Changes in Battery Parts of A6BAT, A8BAT, and A10BAT (Manufactured in and after March 2022)

February 2022

A6BAT, A8BAT, A10BAT

FA-A-0353-A

1 DETAILS ON THE CHANGE

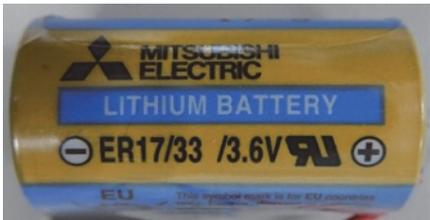
Each model has changes in the following items due to the change of the lithium battery.

- A6BAT: External appearance, label, lithium content
- A8BAT, A10BAT: Lithium content

Note that these changes do not affect the battery lives.
